PLANNING NMA

Eton House | Explore
18-24 Paradise Rd, Richmond TW9 1SE

Rev 01

1 Consented vs Proposed Drawings

1.11 Consented - Roof Plan

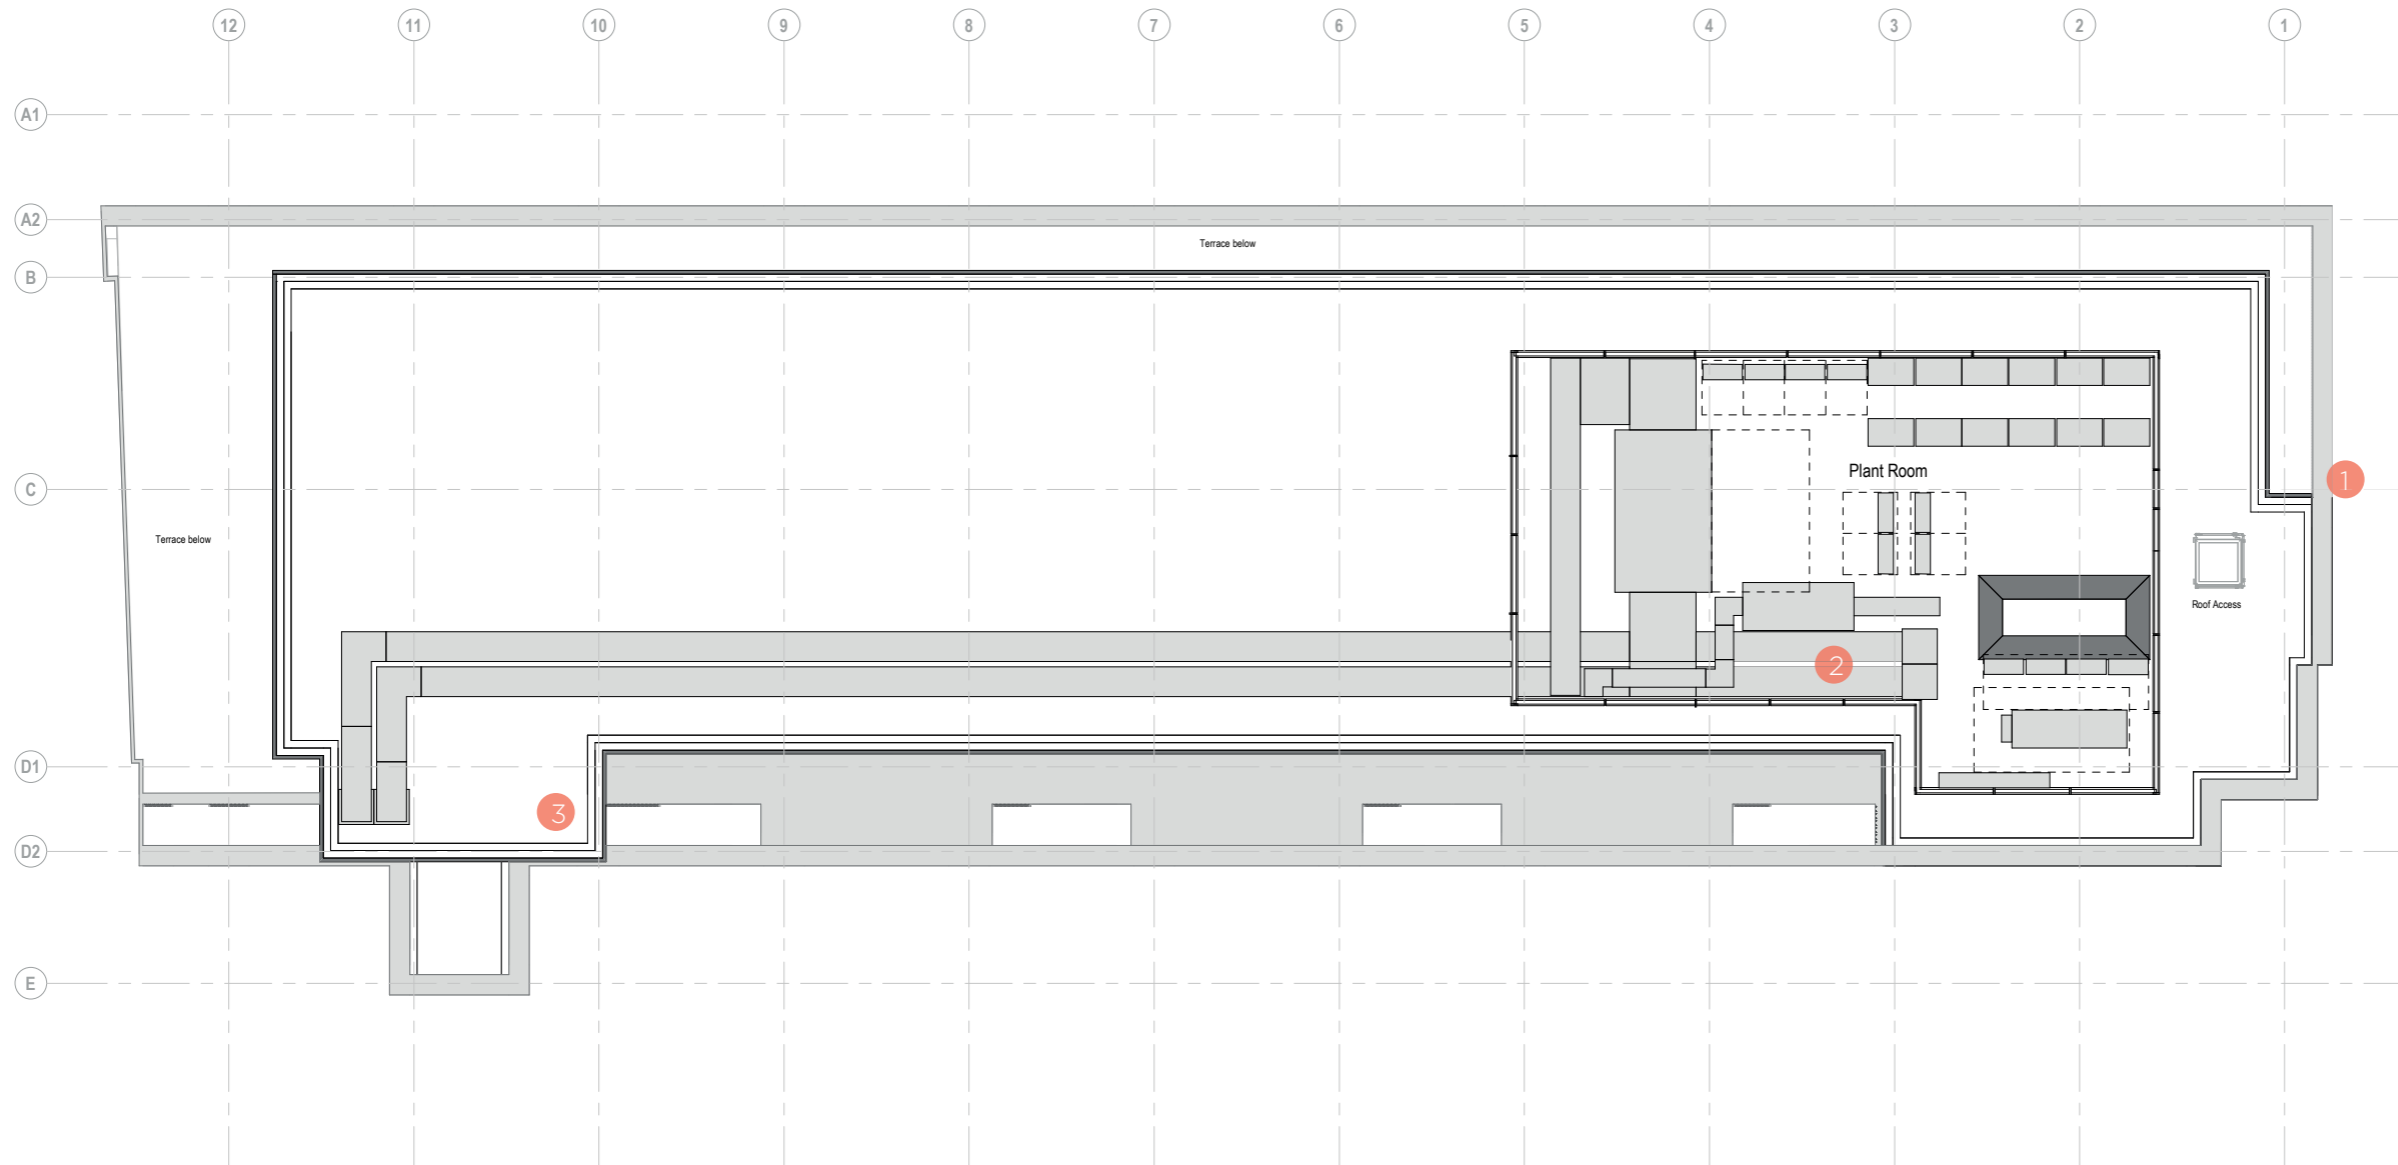
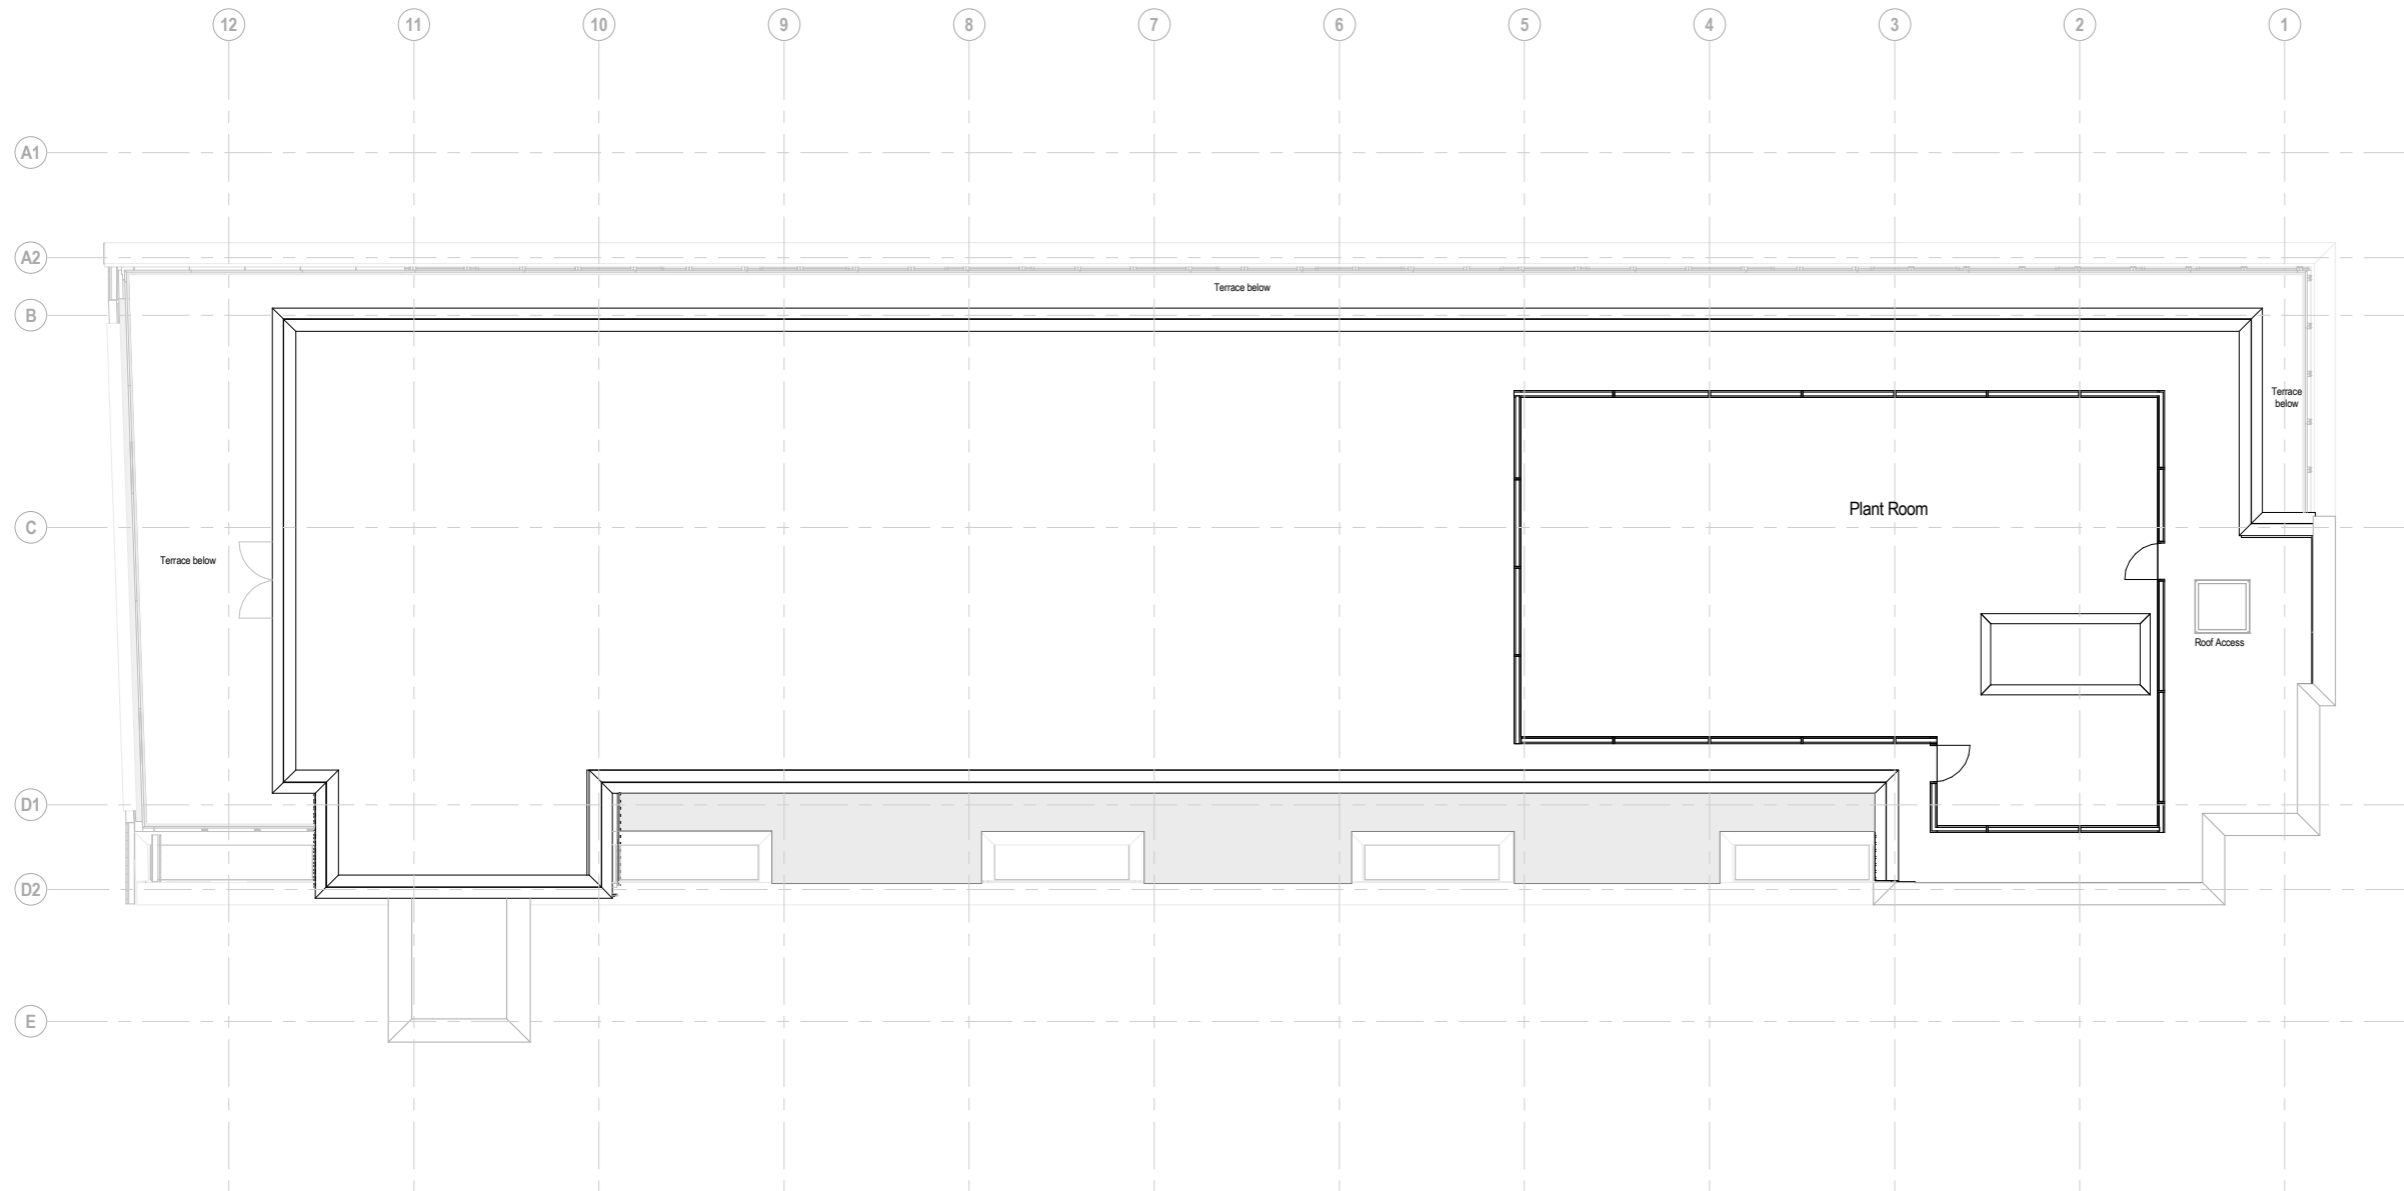
- 1 Marginal adjustment to wall position to suit existing structural discovered during detailed survey
- 2 Generally plant area is similar to planning though the screen itself is now formed of acoustic louvres rather than mesh as shown on elevations
- 3 Ducts come into riser here.

Consented vs Proposed Drawings
 1.13 Consented - Basement Plan

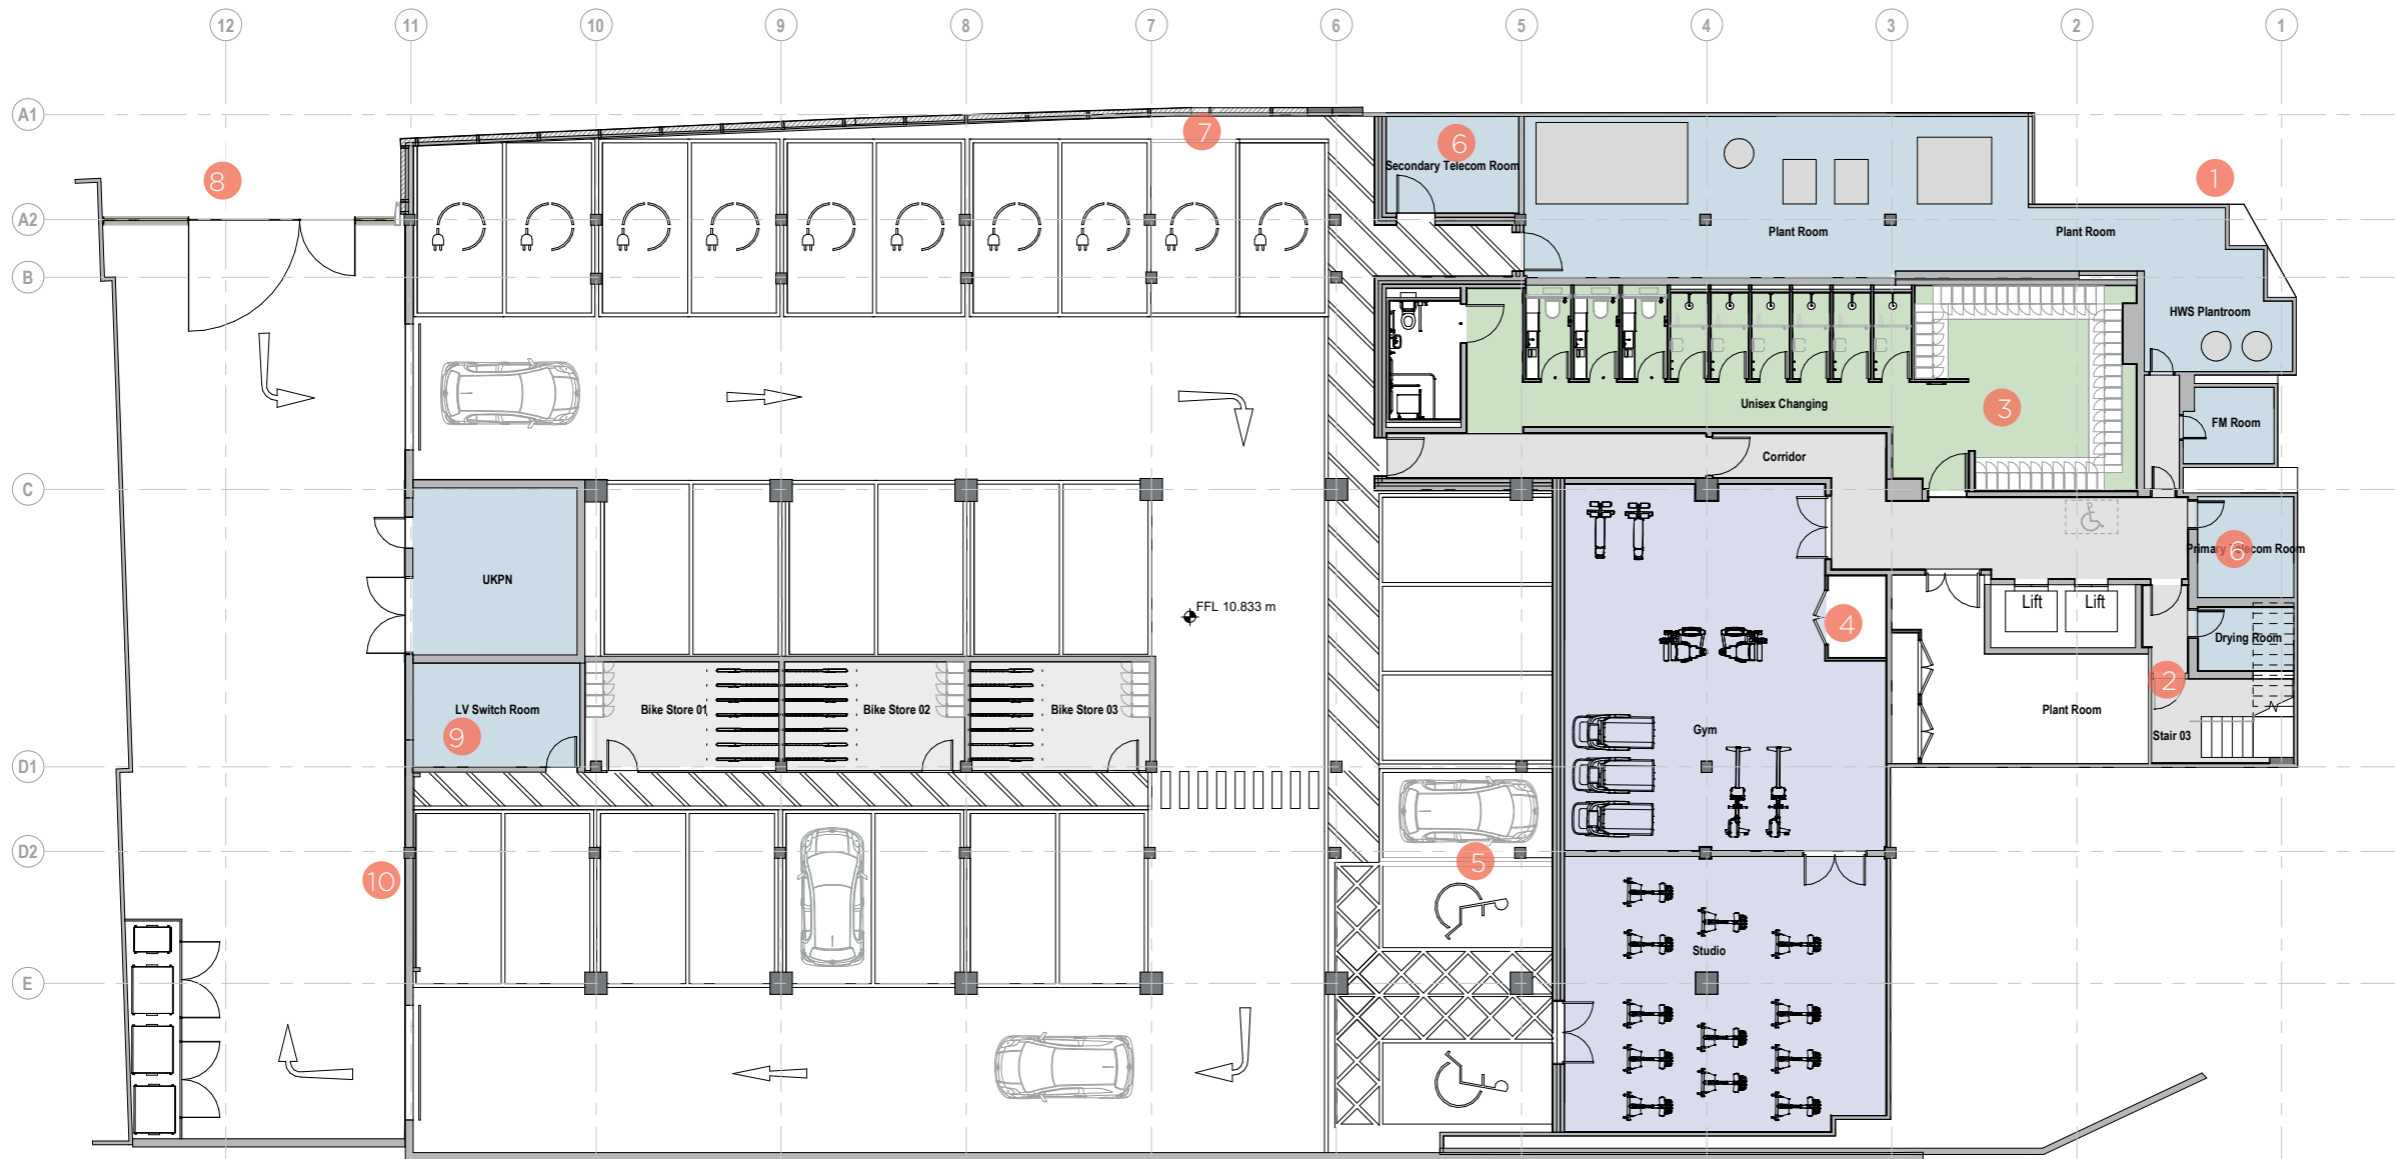
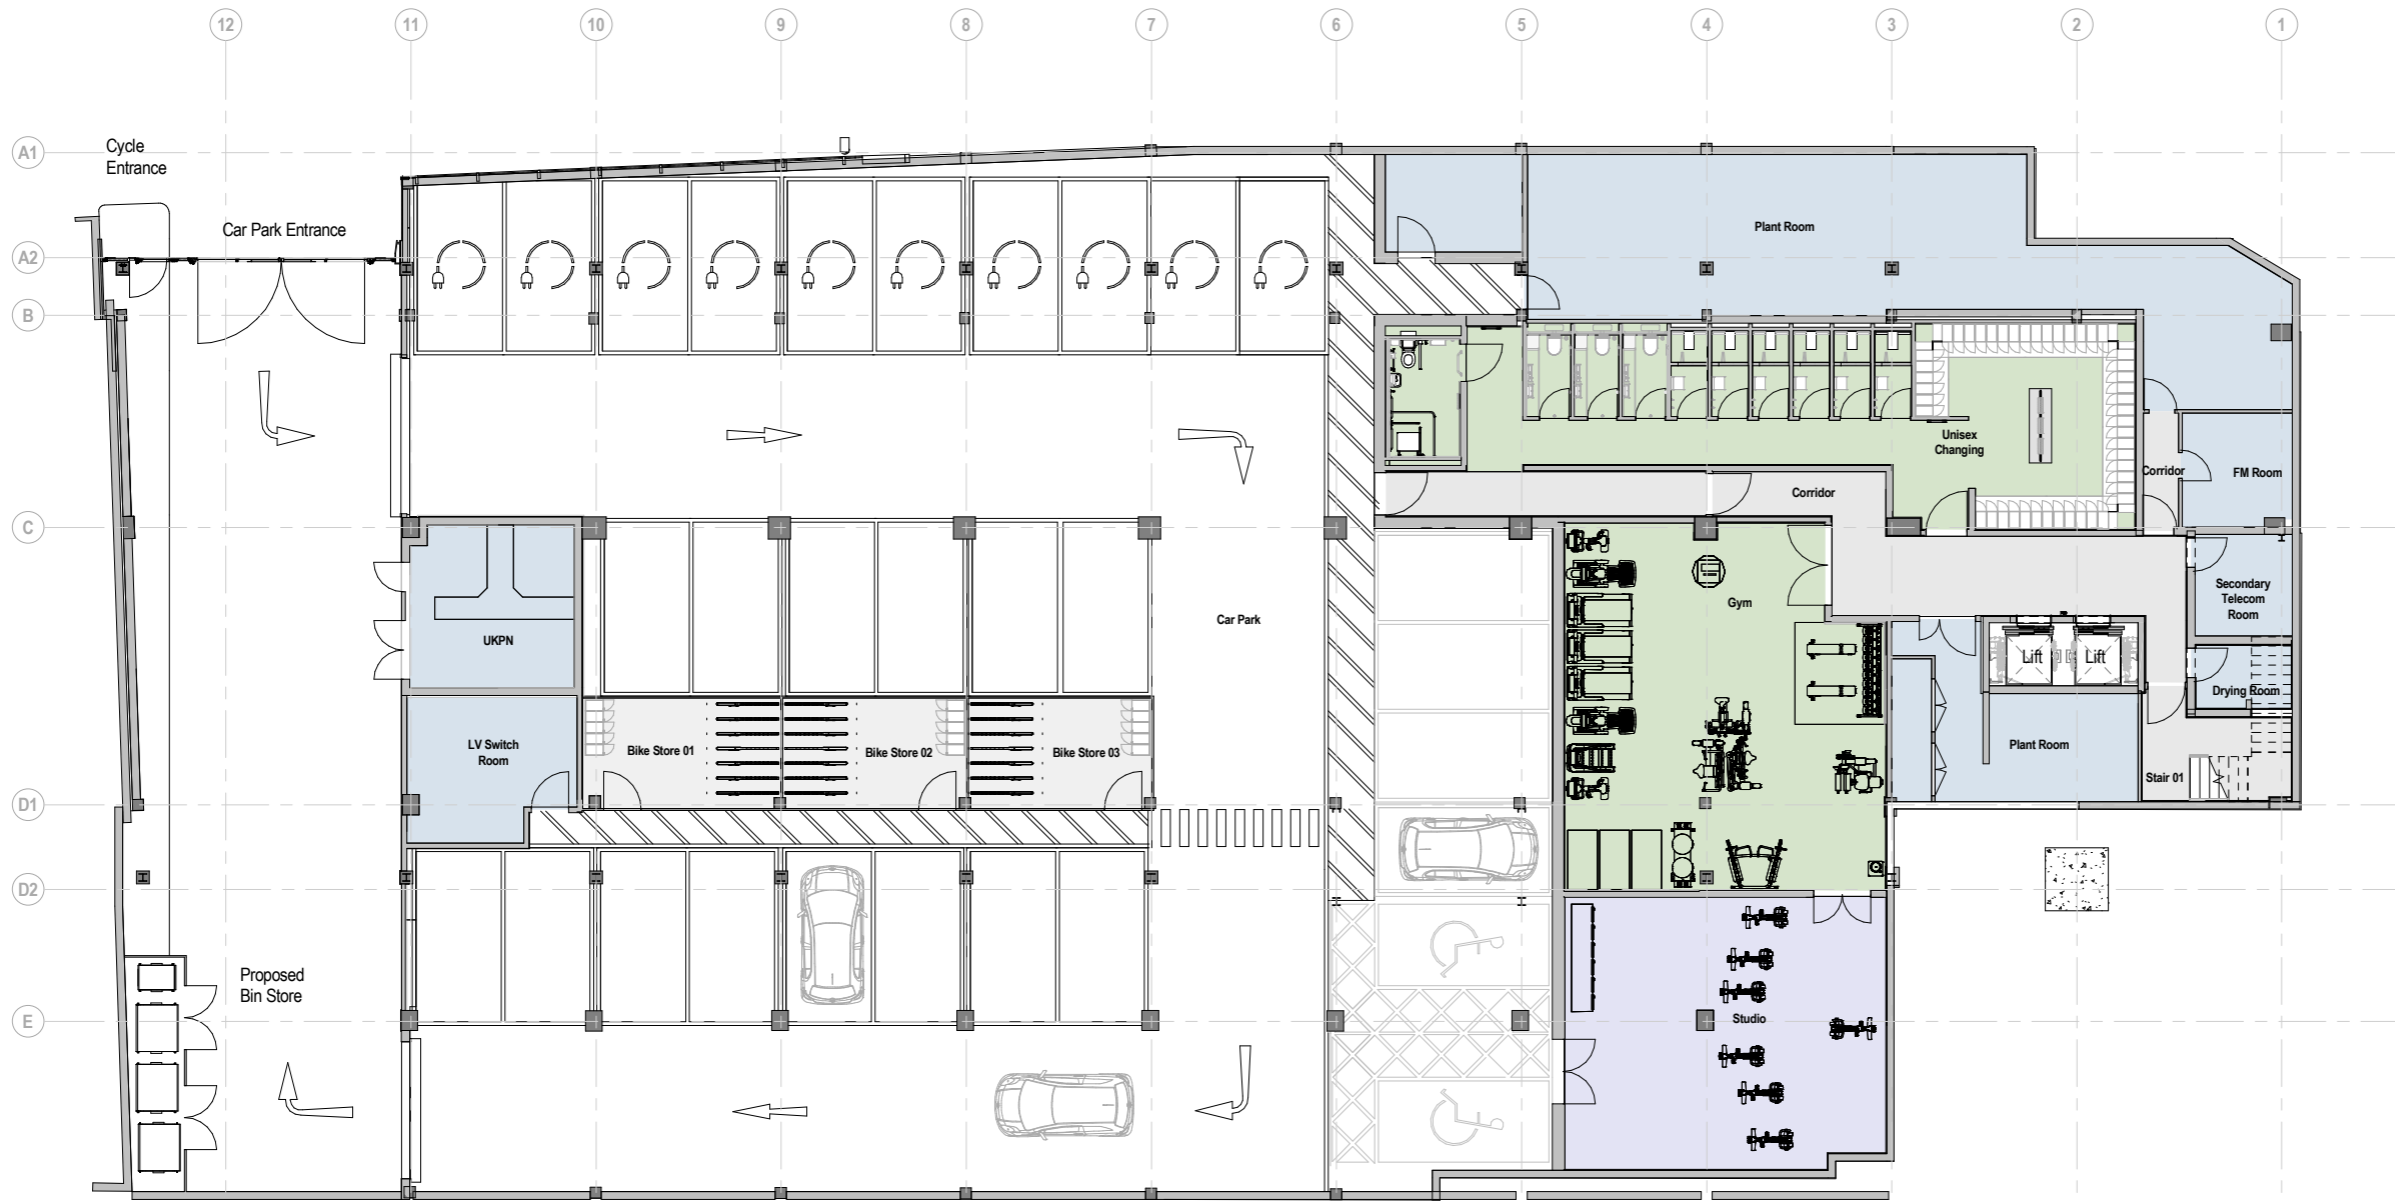
- 1 Adjusted to suit angled rather than stepped condition
- 2 Lobby removed following improvement of layout with fire engineer
- 3 Vanity introduced here
- 4 Cupboard removed
- 5 Columns moved off grid to allow for better parking space provision.
- 6 Primary and secondary telecom rooms have swapped location to allow for improved maintenance access
- 7 Area behind spaces now occupied by plant
- 8 Gate design revised
- 9 Size of room increased as shown
- 10 Introduction of additional louvred screen to achieve smoke ventilation requirements.
